DATE: August 18, 2011
TO: All Prospective Bidders

ADDENDUM NUMBER 2

CONTRACT NO. 60-11

**PRIMARY SEDIMENTATION AND
SLUDGE DIGESTION FACILITIES
AND
NEW LABORATORY, OPERATIONS BUILDING
AND ADMINISTRATION BUILDING RENOVATION**

C113
SHEET
43
OF
230

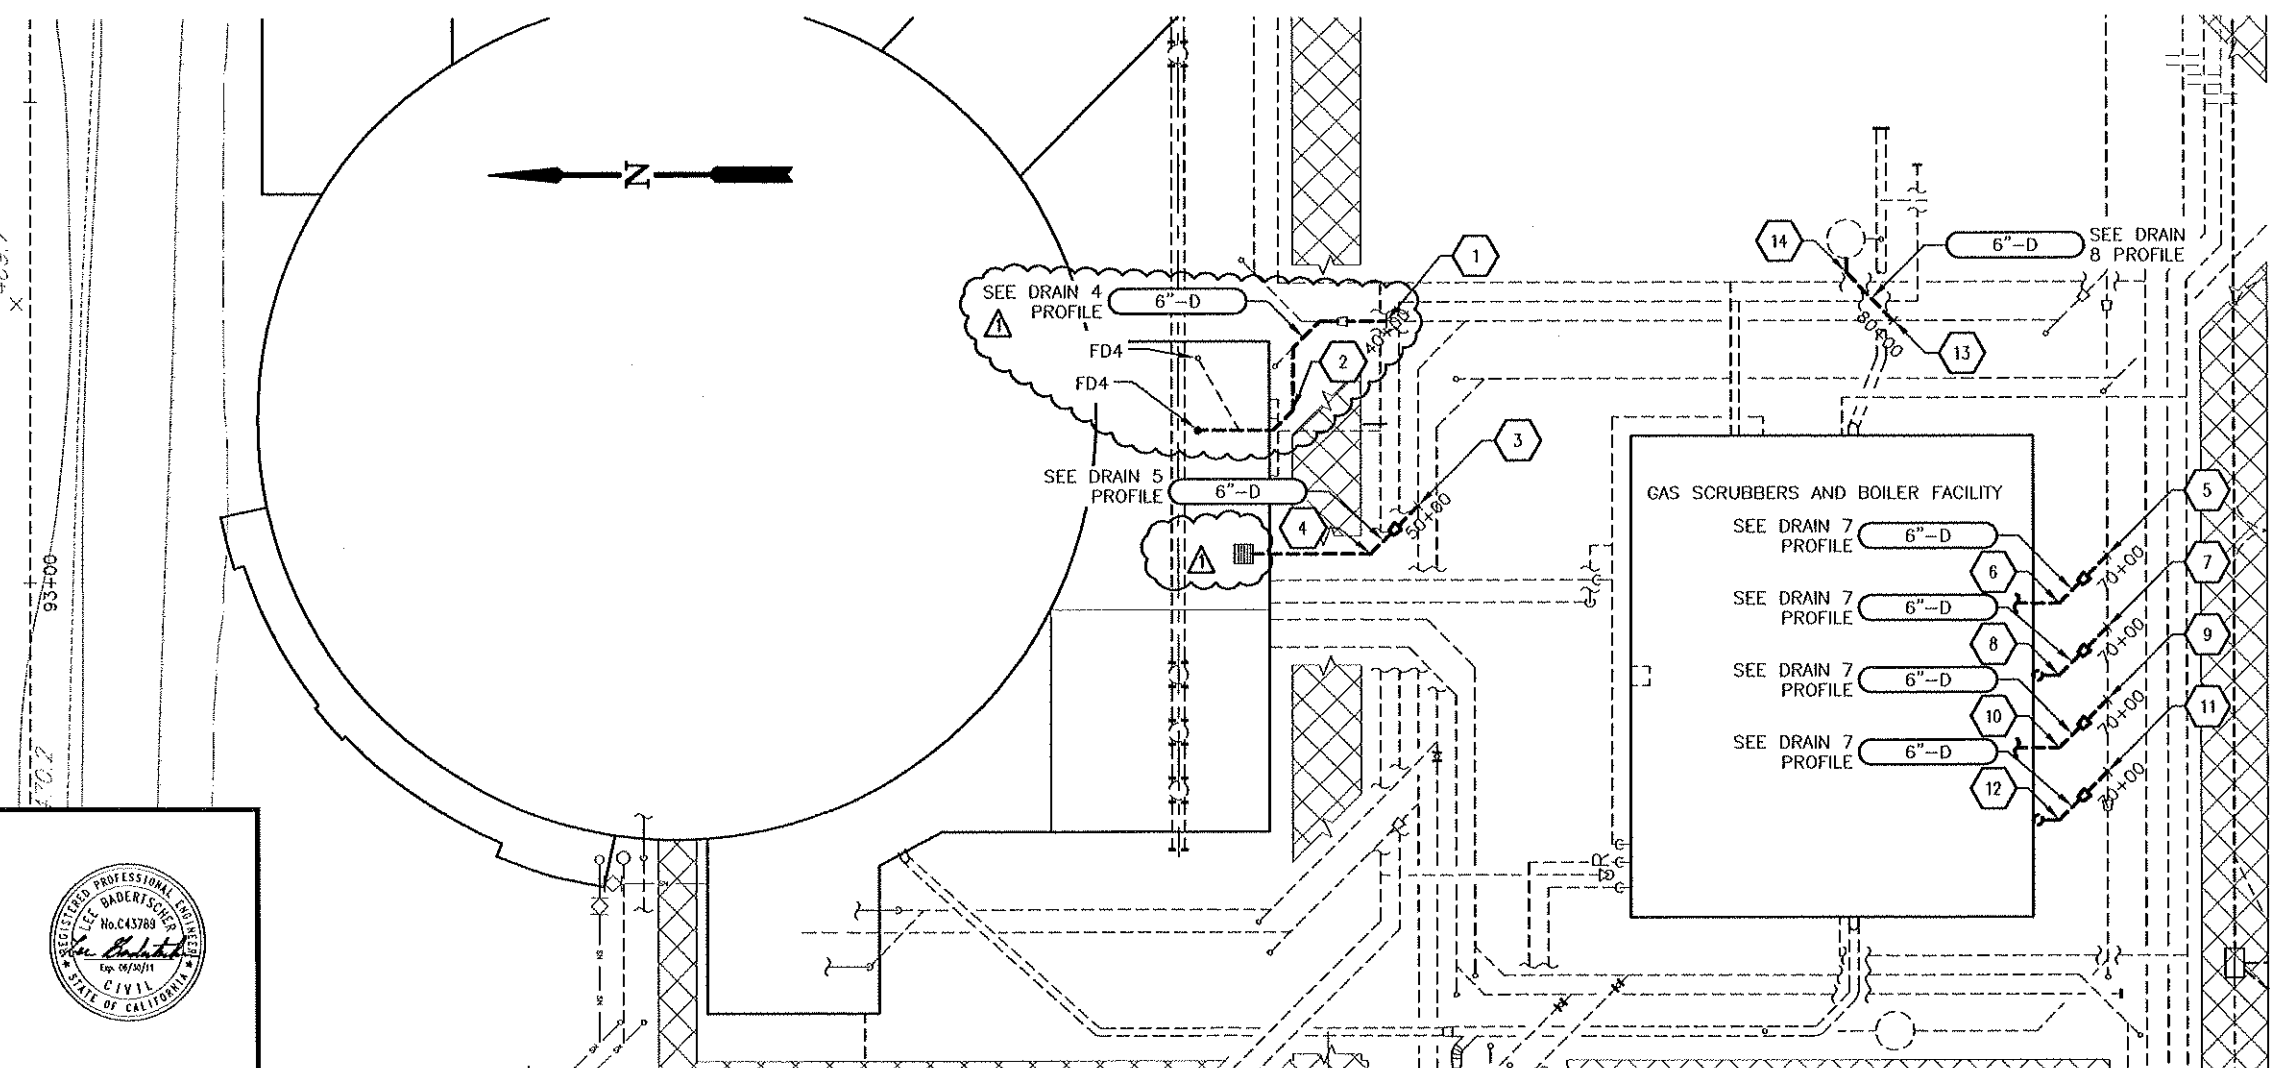
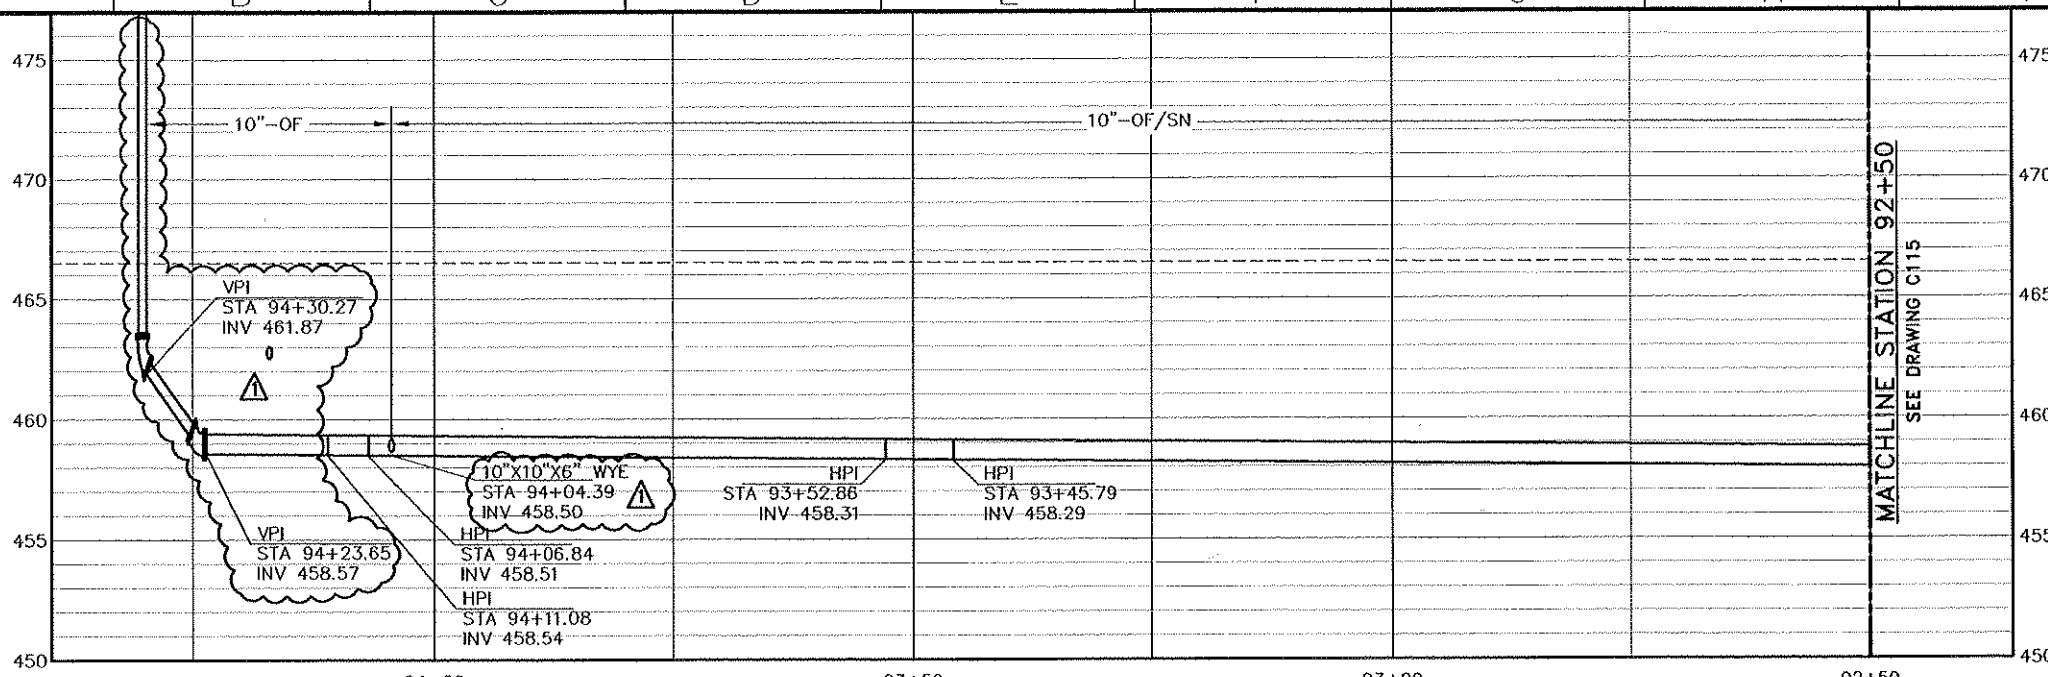
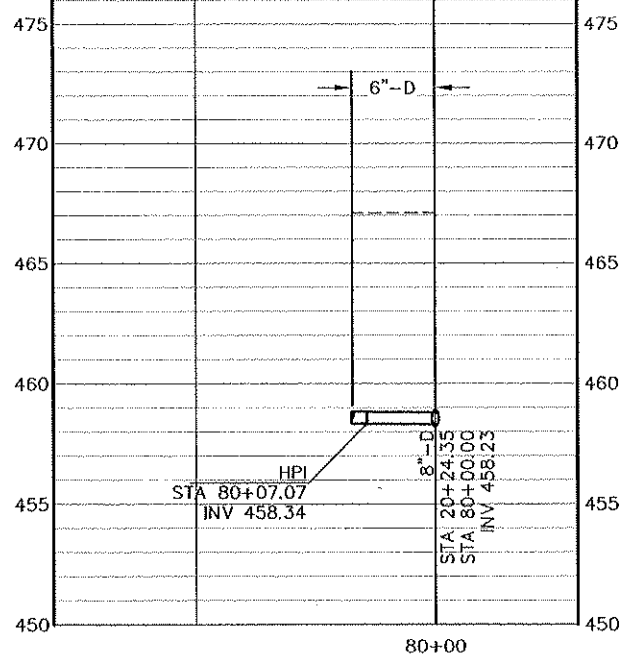
Drawing C111 calls out Drain 4 IE=454.22 at the tie-in to Drain 2 but drawing C113 calls out IE=458.23 for this same location. Please specify the correct invert elevation.

Drawing C111 calls out Drain 5 IE=454.20 at the tie-in to Drain 2 but drawing C113 calls out IE=458.23 for this same location. Please specify the correct invert elevation.

Drawing C113 calls out Drain 8 IE=458.23 at STA 20+24.35 but the yard piping coordinate table calls out IE=452.15 at STA 20+24.35. Please specify the correct invert elevation.

Drawing C113 Drain 4 profile does not match layout shown on plan view on sheets C10 and C113. Please clarify Drain 4 layout.

Drawing C113 will be reissued.

SHEET
 45
 OF
 230

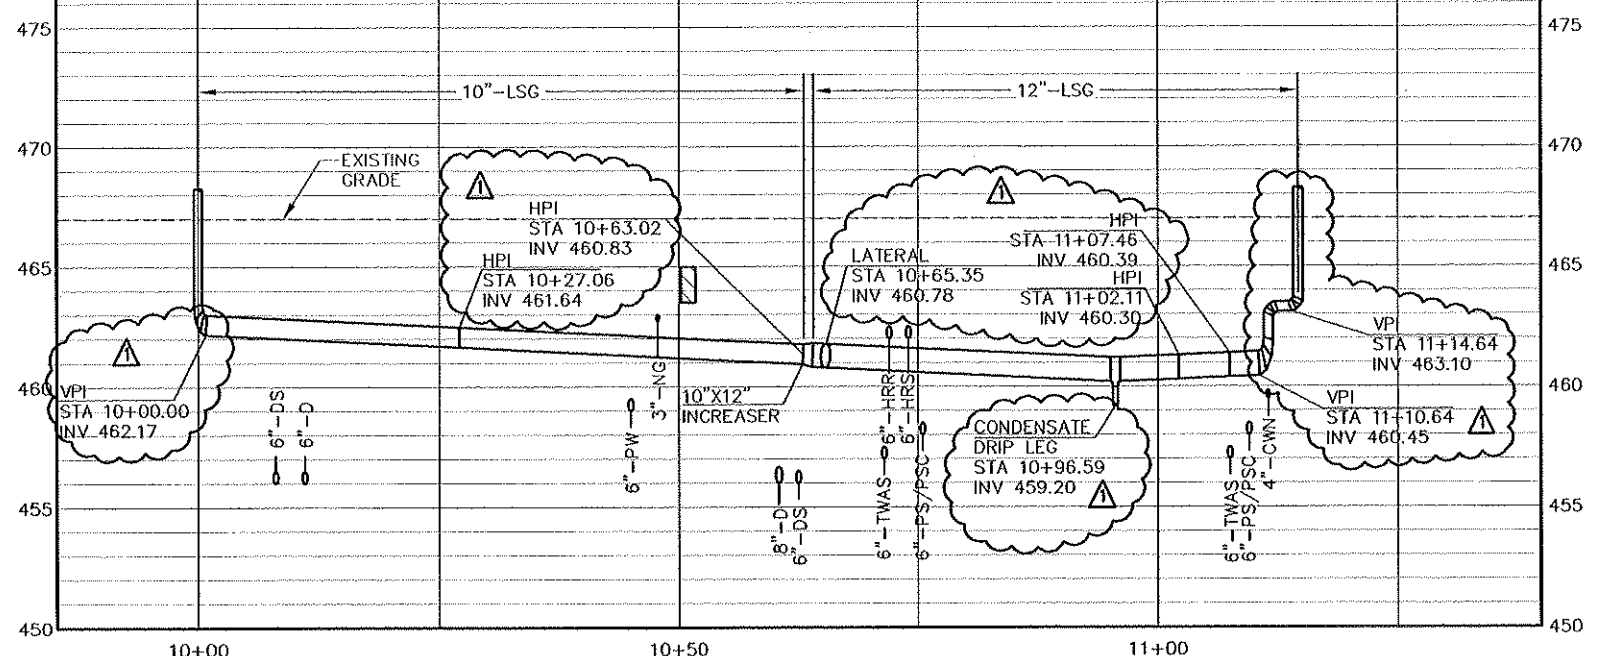
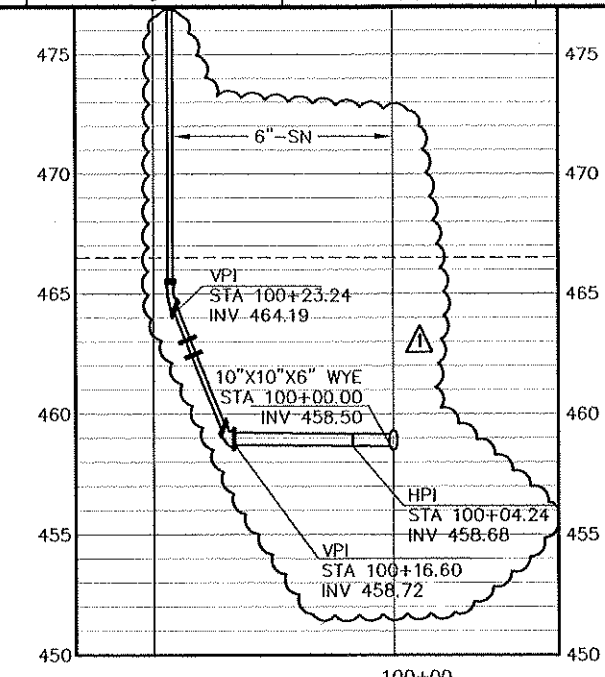
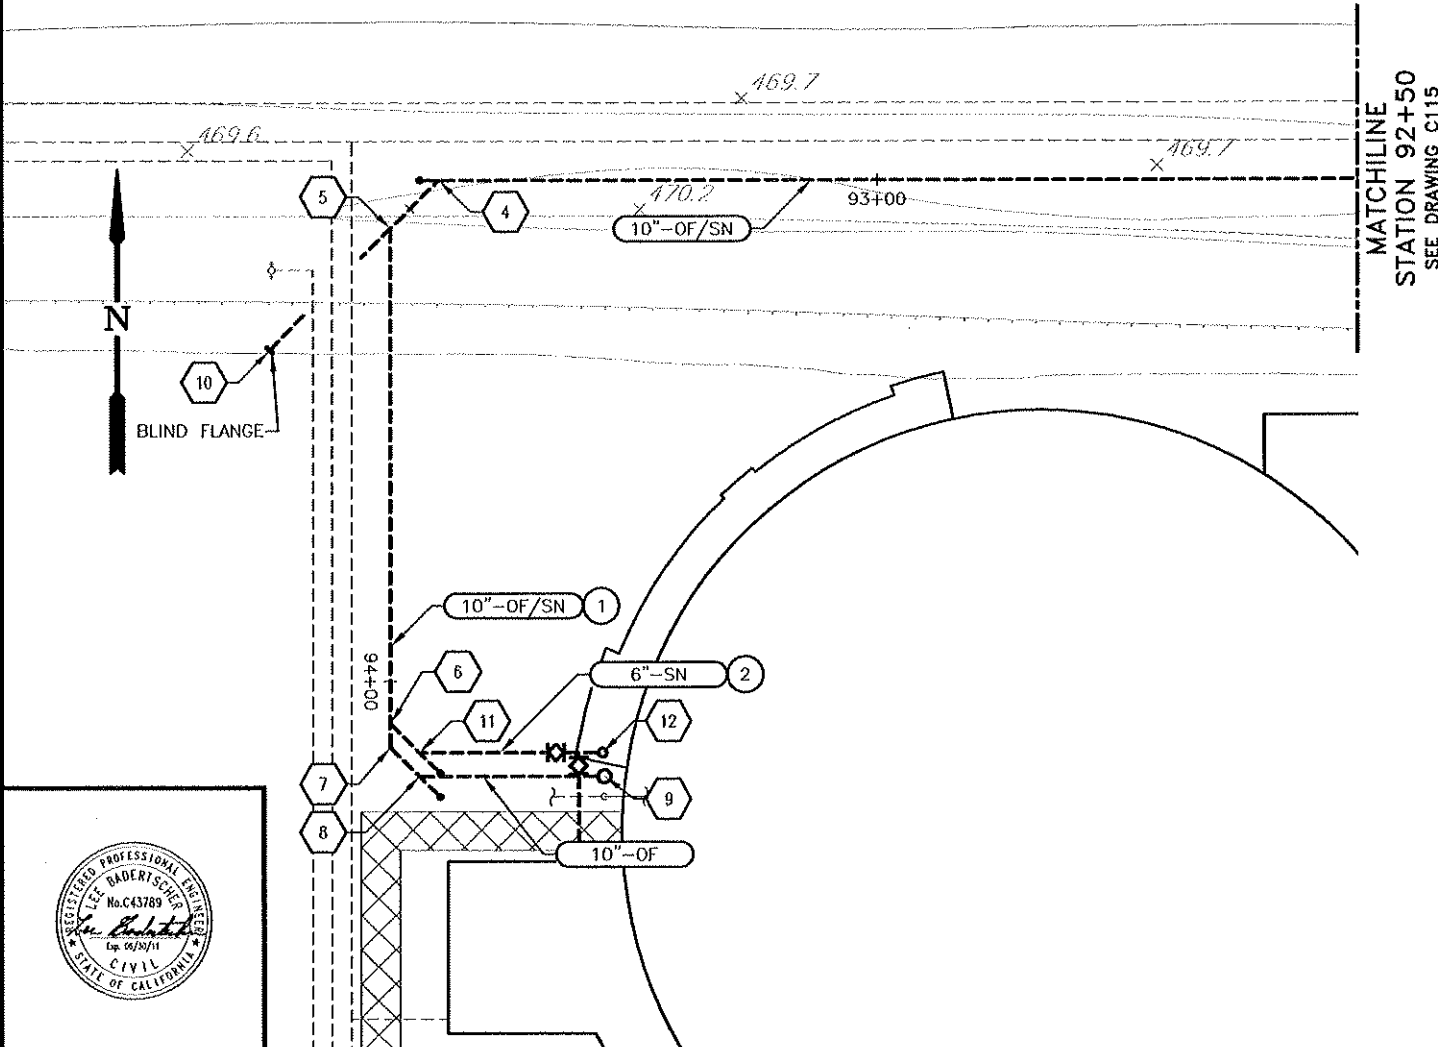
Drawing C116, 10"-OF/SN profile shows a VPI at STA 94+19.19 downstream of a VPI at STA 94+25.87. The stationing appears to be incorrect. Please advise.
